Second Revision No. 10-NFPA 31-2019 [Global Comment]

Update the text throughout the document to incorporate the NFPA 211 (2019 edition) extracts. See attached Word file for reference.

Figure 10.6.3.1 Installation of Down-Flow Furnace on Combustible Floor.

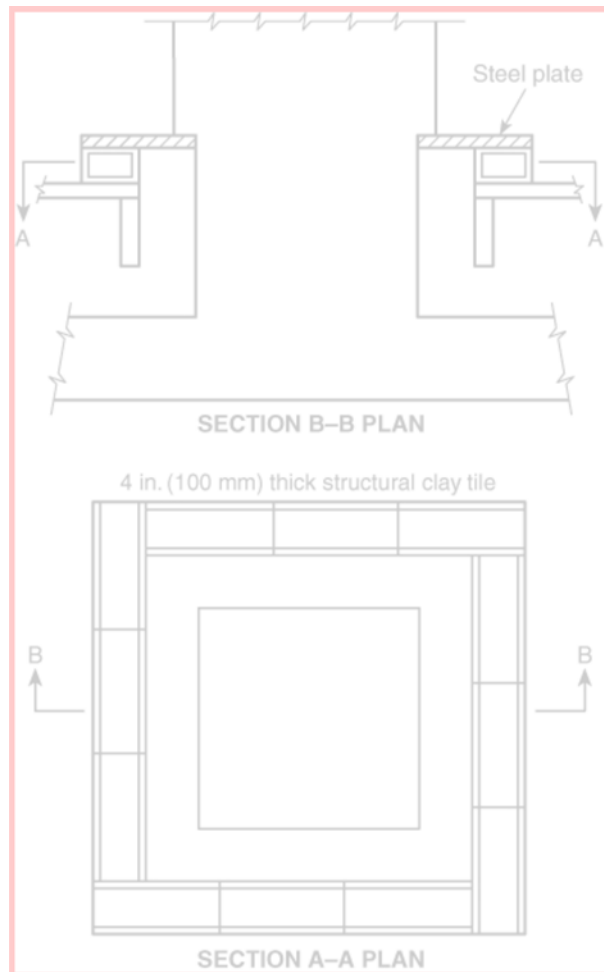
Second Revision No. 9-NFPA 31-2019 [Section No. 10.6.3.1]

This allows a permissible variation for placing the hollow masonry to accommodate a downflow furnace, as shown in Figure 10.6.3.1 Figure 10.6.1 .

An appliance listed for installation under Form I or II in Table 10.6.1 shall be permitted to be placed on a combustible floor that is protected with hollow masonry not less than 4 in. (100 mm) thick covered with sheet metal not less than 24 gauge, as shown in Figure 10.6.3.1 Figure 10.6.1 . Such masonry shall be laid with ends unsealed and joints matched in such a way as to permit free circulation of air from side to side through the masonry. For such installations, the furnace shall be securely anchored to maintain the clearances required in Table 10.6.1.

Committee Statement: Figure 10.6.3.1 is deleted as it is a duplicate of Figure 10.6.1 and is not needed as shown in existing 10.6.3.1. With the deletion of Figure 10.6.3.1, the reference to that figure in 10.6.3.1.2 has also been revised to Figure 10.6.1.
